## PUBLIC INVOLVEMENT PLAN

FORMER BOSSI'S SERVICE STATION  
RTN 3-18598  
12 SWANTON STREET  
WINCHESTER, MA 01890

August 5, 2013

REMSERV responses are provided in *italics* to questions received on July 29, 2013 following the closure of the comment review period for the DRAFT Public Involvement Plan review period.

Figure: 2

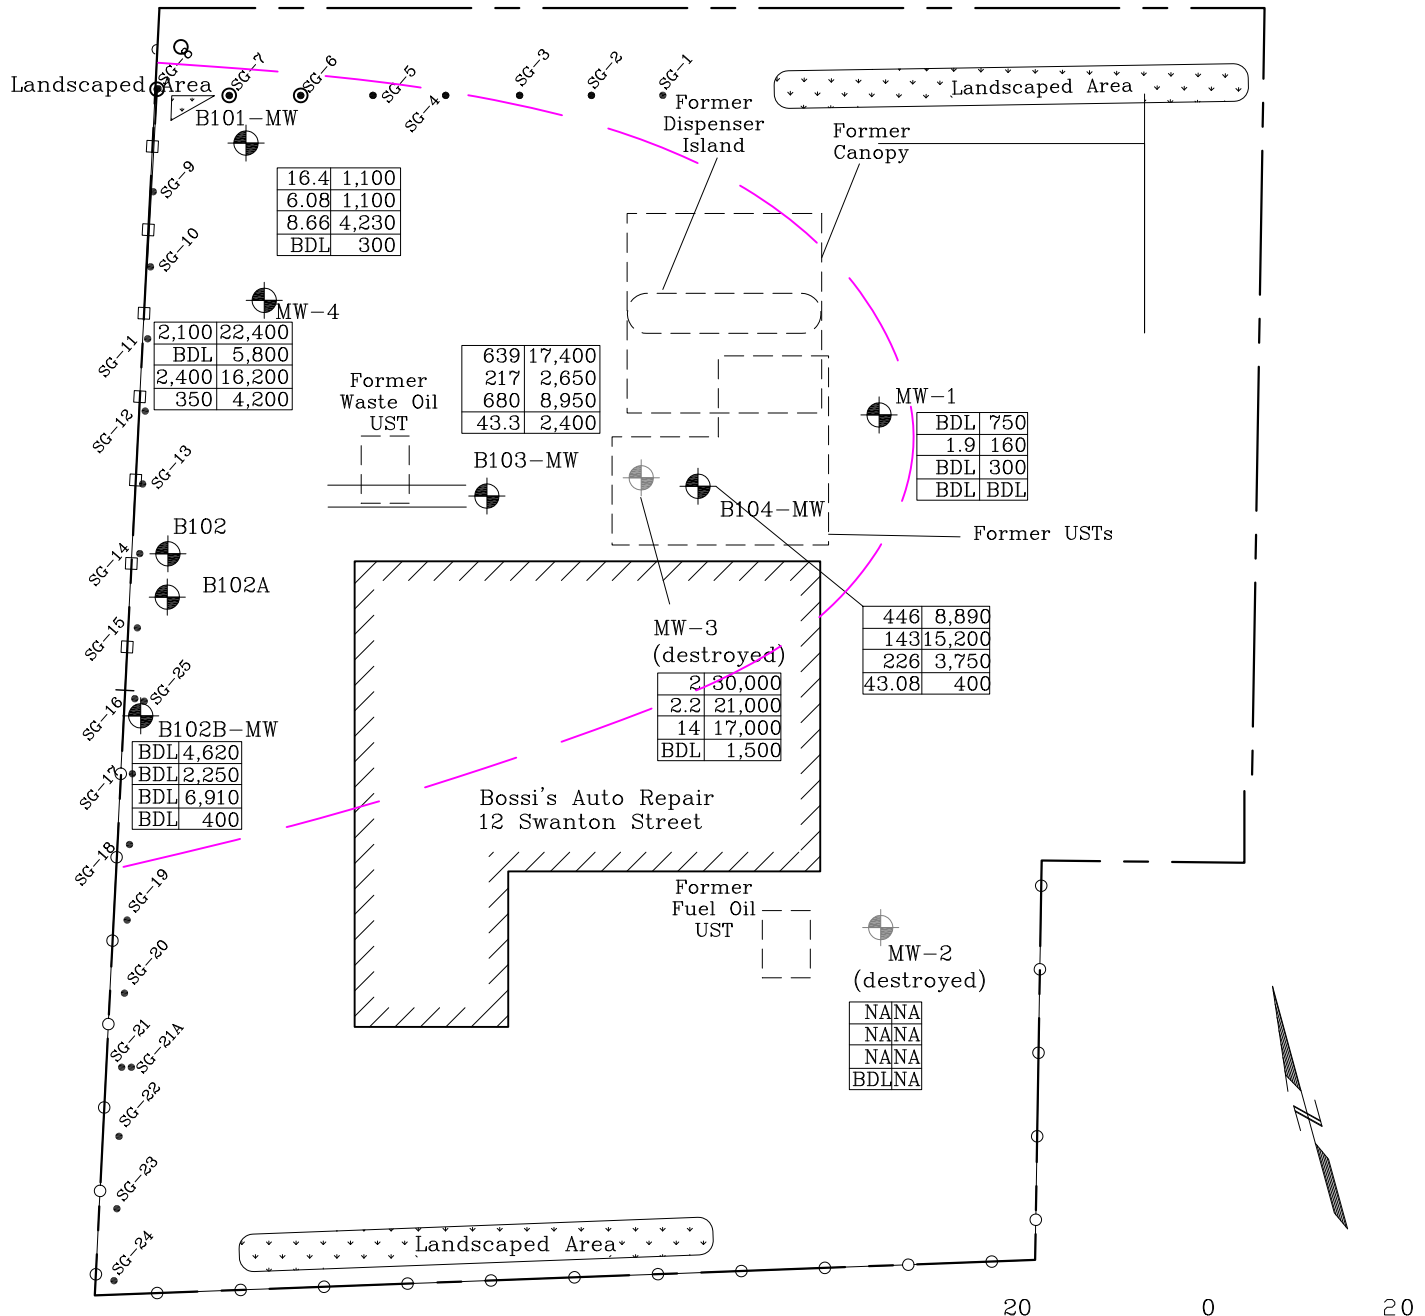
Q20: This question has not been answered. The intent was to know which samples were used to calculate the current model of the plume. Further, the specific assumptions used for these projections are desired. If this is existing in the current documentation, that is acceptable, but it has escaped my notices so far, please point to it.

*The plume has not been modeled to date. The horizontal extent of the contamination has been assessed and is shown in its current depiction on the attached figure. Included in the assessment of extent are the soil contaminants, soil gas vapors along the property boundary and dissolved contaminant concentrations. Together this information has been used to estimate human health risk associated with the subsurface conditions.*
